Value Engineering Study Report

Georgia Department of Transportation

CSMSL-0008-00(690) - P.I. No. 0008690
Jimmy Deloach Connector - from Bourne Ave./SR 307 to existing
Jimmy Deloach Parkway

February 17, 2010

TYPICAL SECTION
AT DIVIDED HWY BRIDGES
(LOOKING AHEAD)

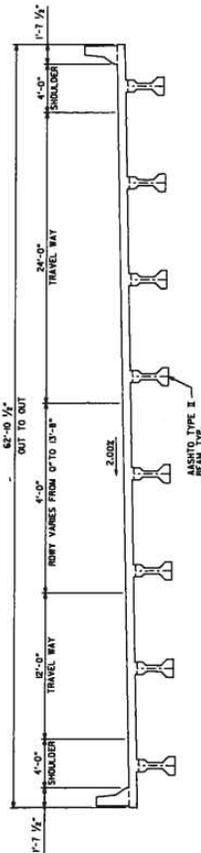
The original bridges (NB bridge and SB bridge) typical section for the Jimmy Deloach Connector over the Wetlands calls for the use of a 4'-0" and an 8'-0" shoulder.

The alternative proposes reducing the shoulders width from 8'-0" to 4'-0". The proposed shoulder width reduction will be in compliance with the GDOT Policies and Procedures (Minimum Bridge Widths) and Exhibit 6-5, Page 425 (Minimum Width of Traveled Way and Shoulders) of the AASHTO Geometric Design of Highways and Streets (2004).

The use of 4'-0" outside shoulder between the travel lane and the bridge barrier is adequate for bridge lengths greater than 200'-0" (long bridges), per AASHTO Geometric Design of Highways and Streets (Page 447, Paragraph "Structures").

Replacing the 8'-0" shoulders with 4'-0" shoulders could potentially reduce the bridges out-to-out width by 4'-0".

S.B. PLAN - ORIGINAL DESIGN

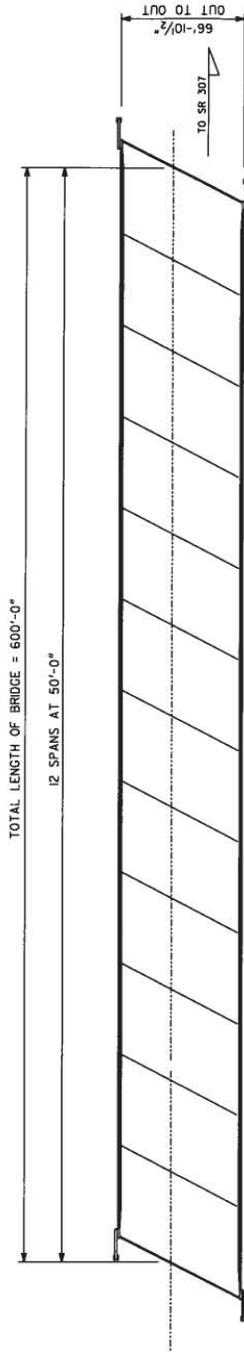
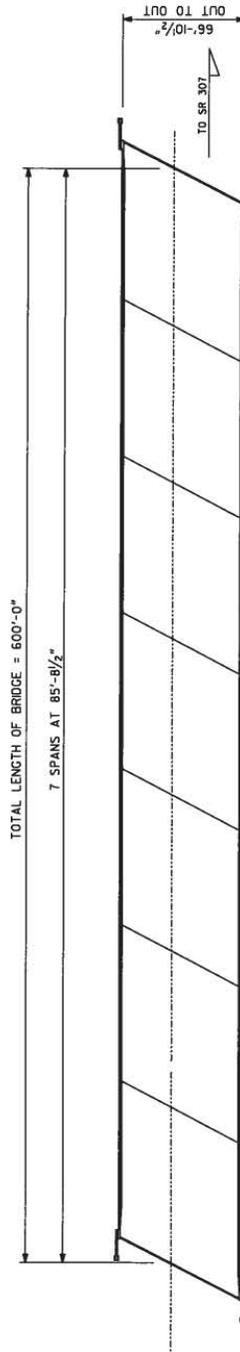
The 600'-0" (twelve equal spans) long SB bridge will be 66'-10 ½" wide and its CIP superstructure will be supported by eight AASHTO Type II PSC beams.

The alternative proposes the reduction of total number of spans for both bridges over the wetlands.

SB Bridge: Reduce span number from 12 spans to 7 equal spans (85'-8 ½" long each). CIP superstructure supported by 6-AASHTO Type III PSC Beams.

The reduction of number of spans at both locations will reduce potential impacts to the wetlands and provide a potential savings in construction cost.

N.B. PLAN - ORIGINAL DESIGN

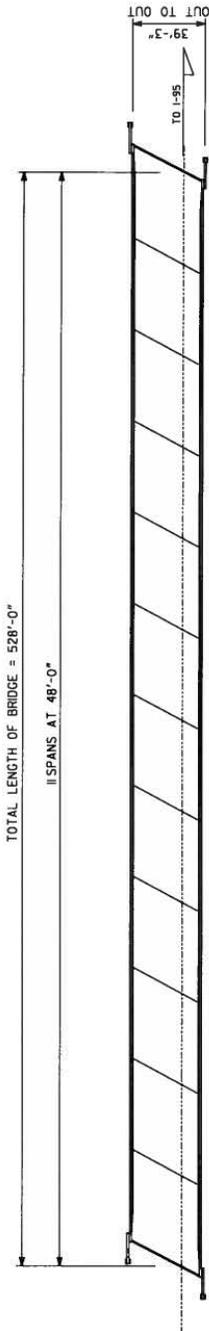
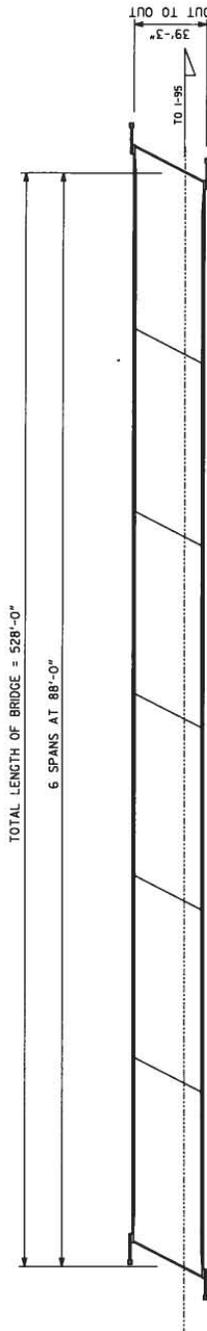
The 528'-0" (eleven equal spans) long NB bridge will be 39'-3" wide and its CIP superstructure will be supported by five AASHTO Type II PSC beams.

NB Bridge: Reduce span number from 11 spans to 6 equal spans (88'-0" long each). CIP superstructure supported by 6-AASHTO Type III PSC Beams.

DESCRIPTION: Use median barrier in-lieu of raised grassed median section

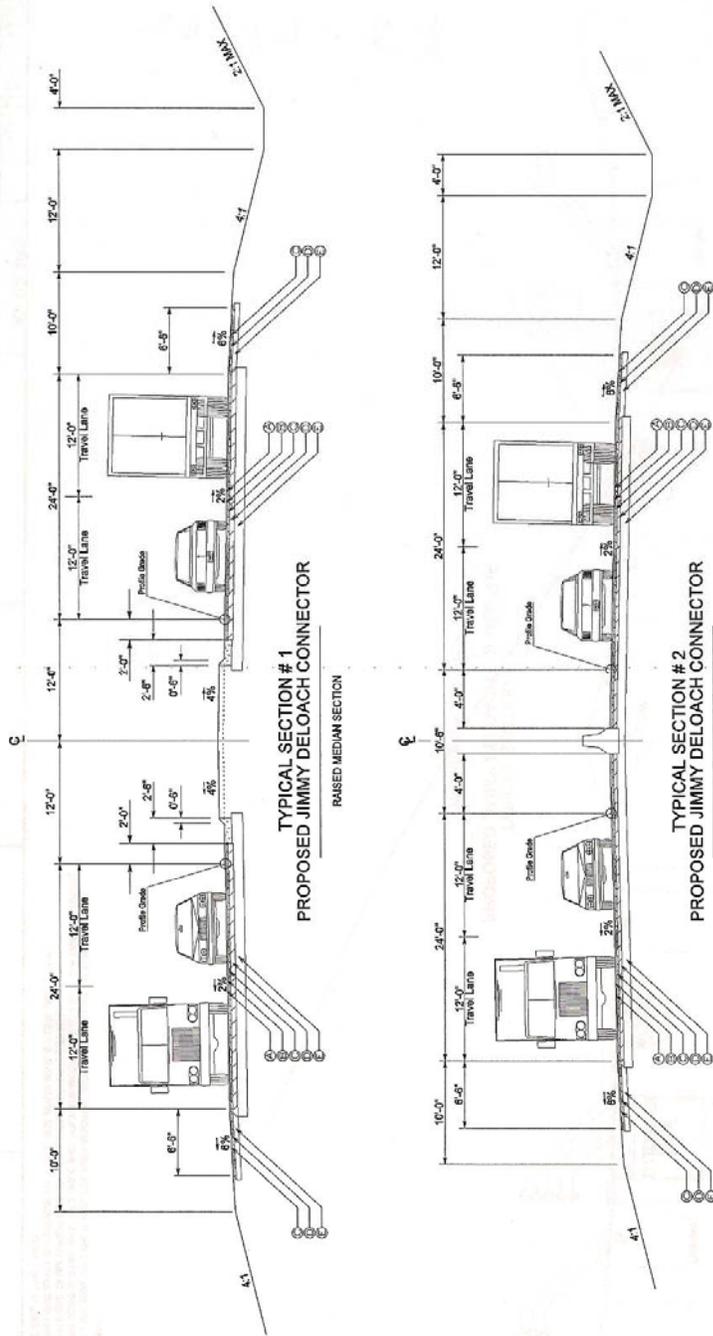
The original design proposes a section of raised grassed median with curb & gutter from Sta. 162+00 to Sta. 230+00. (See Section 1 in Illustrations).

The alternative design would replace the raised grassed median with the median barrier section. (Section 2 in Illustrations).

The Original Design has a transition in the design section at 230+00 from a raised grassed median section to a median barrier section. Since both design sections are acceptable, the alternative design proposed to use the less costly design for the entire length of the project. The advantages of the alternate design require a smaller footprint, resulting in less impact to the wetlands and less required ROW. In construction terms the alternate design requires less earthwork, less structures (bridge and MSE wall), but requires more pavement area. The drainage requirements will be equal. An additional advantage of the alternative design of the median barrier is the elimination of the maintenance of the raised grassed median (mowing).

DESCRIPTION: **Construct a typical intersection at Bourne Avenue**

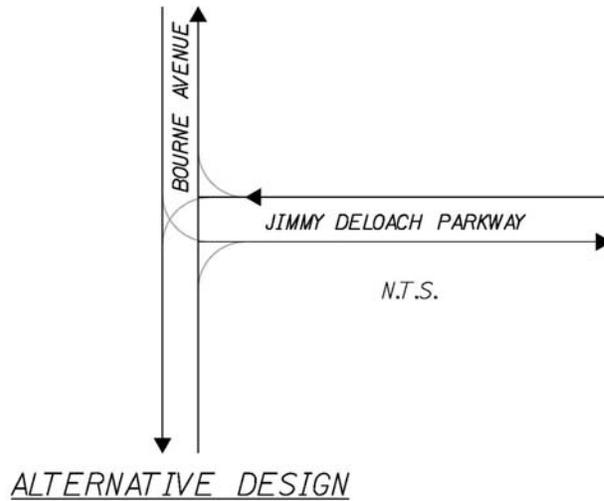
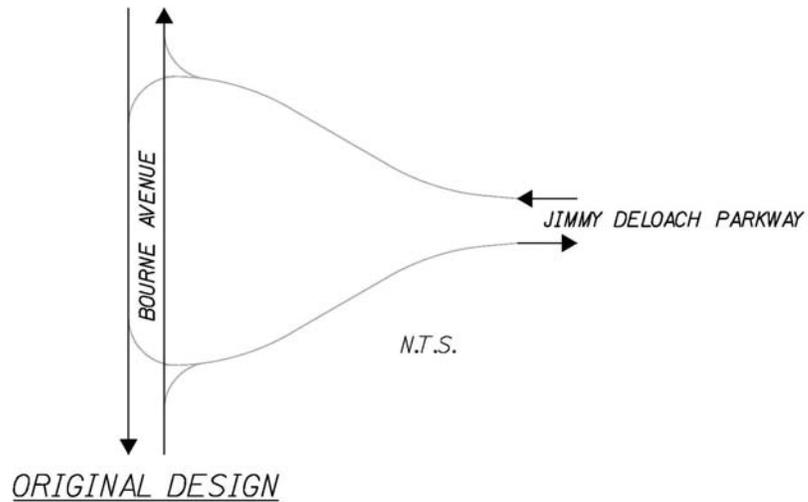
The original design proposes constructing a “split” intersection at Bourne Avenue that allows future construction of a Diamond Interchange.

The alternative design would propose constructing a conventional intersection at Bourne Avenue.

The alternative dramatically reduces the footprint of the intersection. While accommodating future improvement is generally good practice, the possibility of future improvements actually being built should be taken into account. It should be taken into consideration whether a direct connection to SR 21 serves any compelling function. The primary function of the roadway is to serve the port and it provides three points of access to SR 21 traffic wishing to access facilities served by Jimmy Deloach Parkway. It should be noted that accommodating a future connection to SR 21 may have some value with respect to providing “system connectivity” between I-516 and existing Jimmy Deloach Parkway and the proposed southern extension of Jimmy Deloach Parkway.

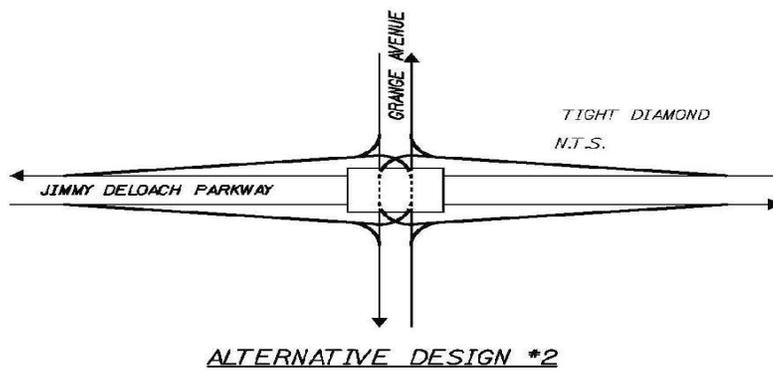
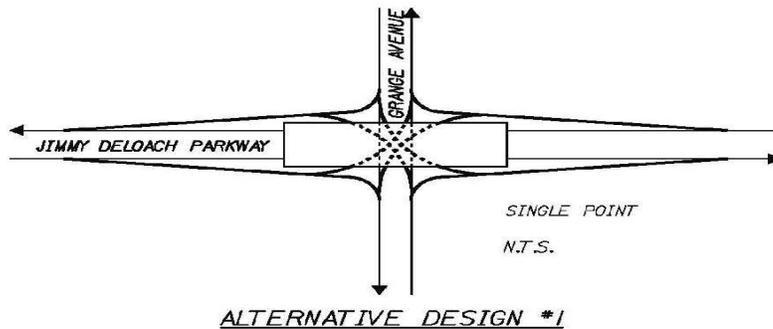
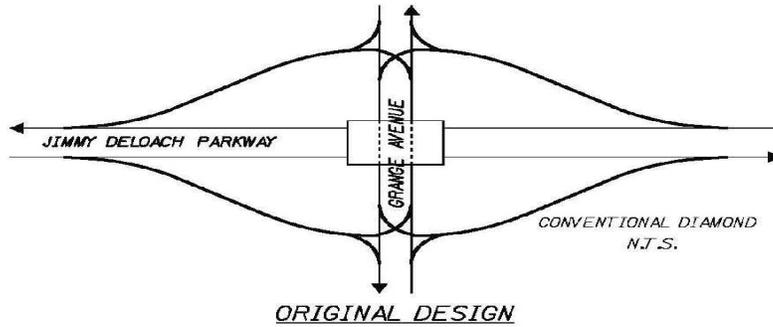
The alternative dramatically reduces the footprint of the intersection in an area with heavy industrial/commercial development. It would require addition of retaining walls and additional roadway barrier. The proposed alternative should provide a similar level of service with no drop in operational efficiency.

DESCRIPTION: Delete northbound exit and southbound entrance at
Grange Avenue

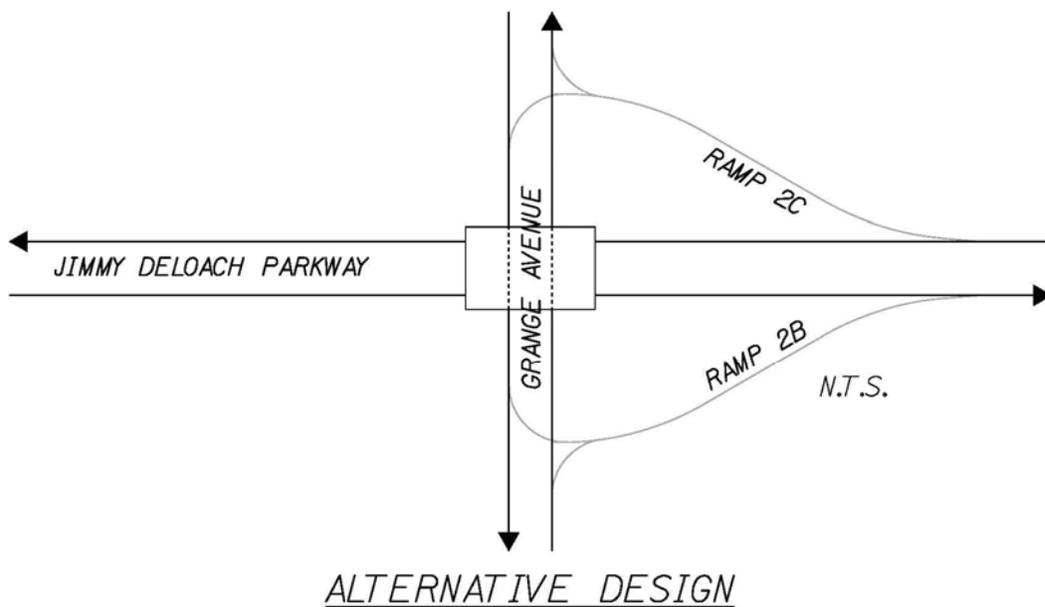
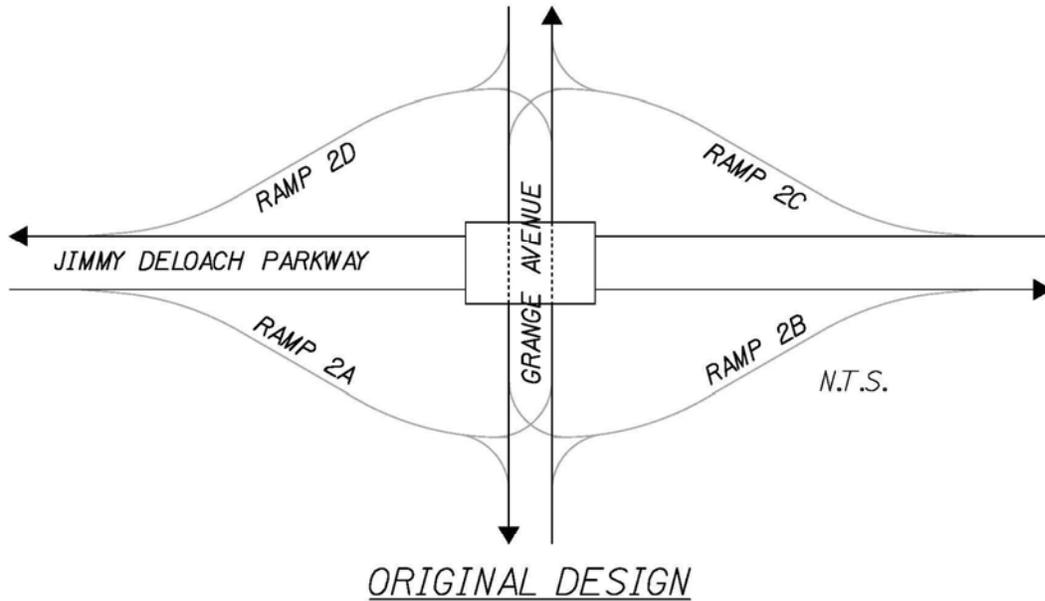
The Original Design calls for a full diamond interchange at Grange Rd. / Jimmy Deloach Connector. The stated purpose of the project is to provide clear access for trucks from existing Jimmy Deloach Pkwy. to the Main Gate of the port. The traffic projections show relatively low volumes for the Design Year 2032 for the NB Exit Ramp and the SB Entrance Ramp. The Alternative Design proposes to eliminate the NB Exit Ramp and the SB Entrance Ramp since they are not a project priority and have low traffic volumes. There are alternate routes readily available, greatly reducing the needs and benefits for the ramps.

PROJECT:	Georgia Department of Transportation CSMSL-0008-00(690) - P.I. No. 0008690 Jimmy Deloach Connector- From Bourne Ave./SR 307 to exist. Jimmy Deloach Pkwy. Chatham County	ALTERNATIVE NO.: RD-21
DESCRIPTION:	Adjust profile to reduce borrow	SHEET NO.: 4 of 4

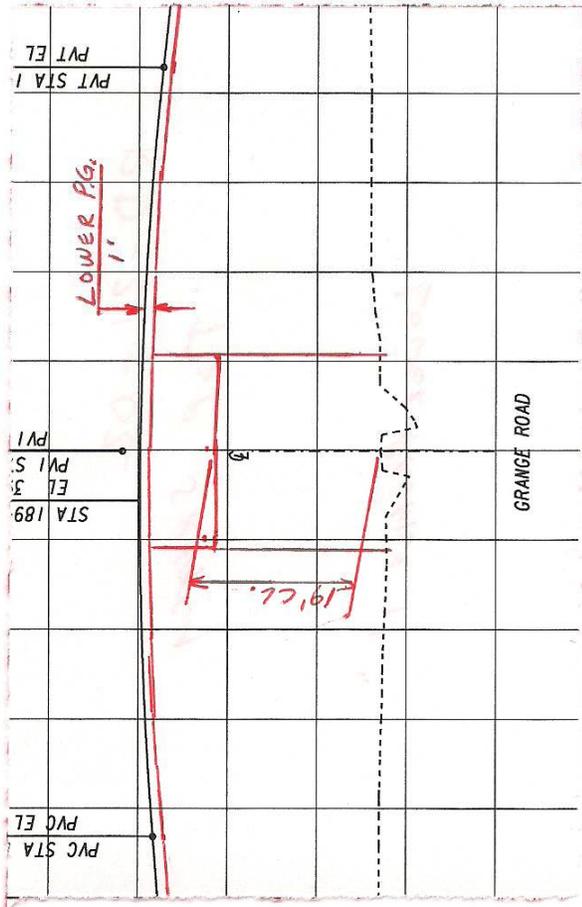
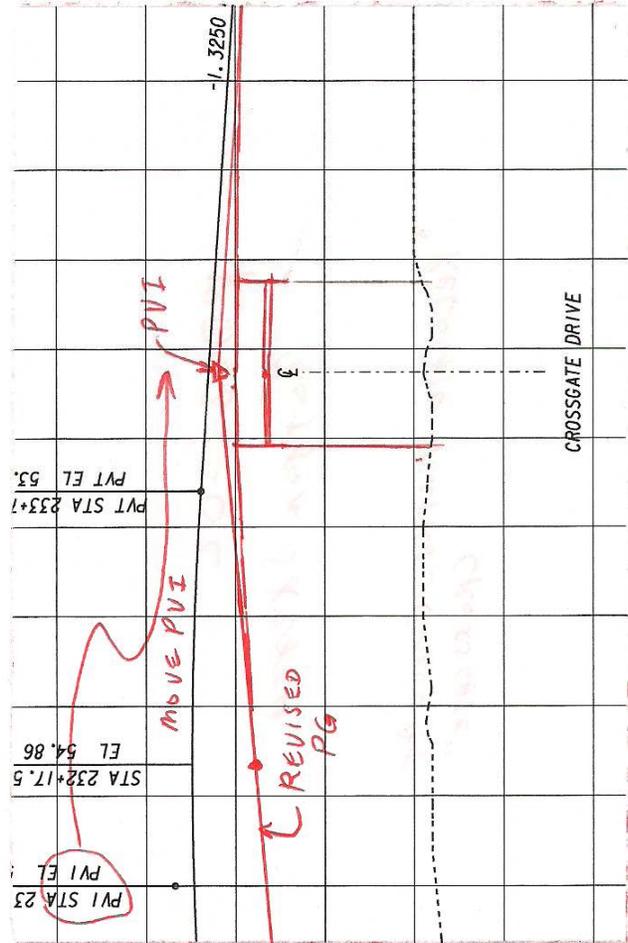
Original Design for Grange in Black

Alternative Design for Grange in Red
